SUMMIT HOMES KC
HIGHLAND MEADOWS - 6TH PLAT

GENERAL LAYOUT

AS-BUILT

SANITARY SEWER 6A AND 6B
PLAN & PROFILE

SANITARY SEWER 6C PLAN & PROFILE

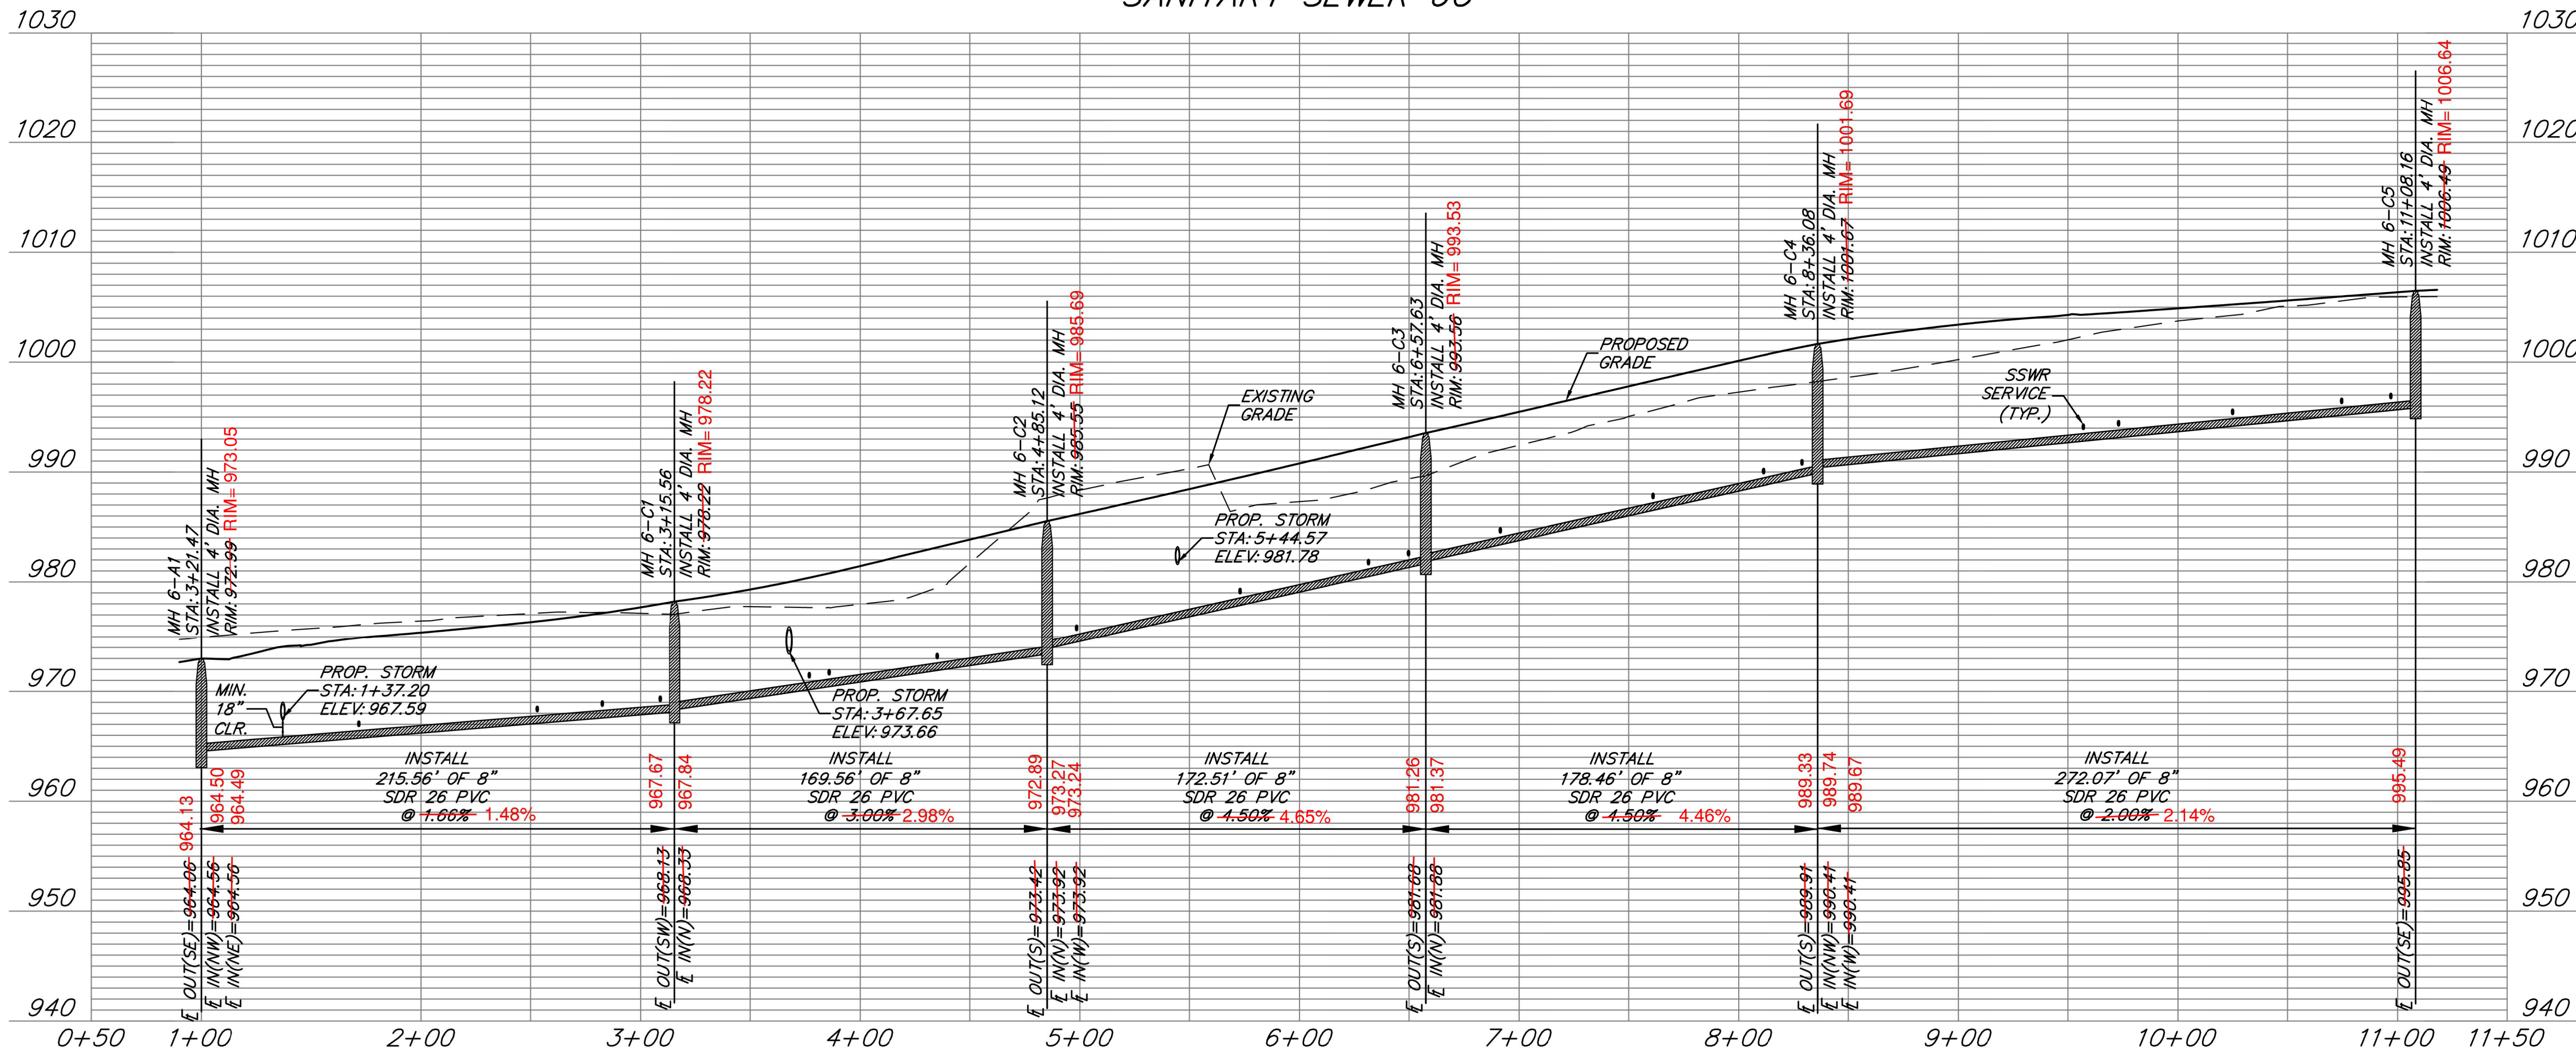
Sewer laterals were constructed per plan as indicated by Redford Construction
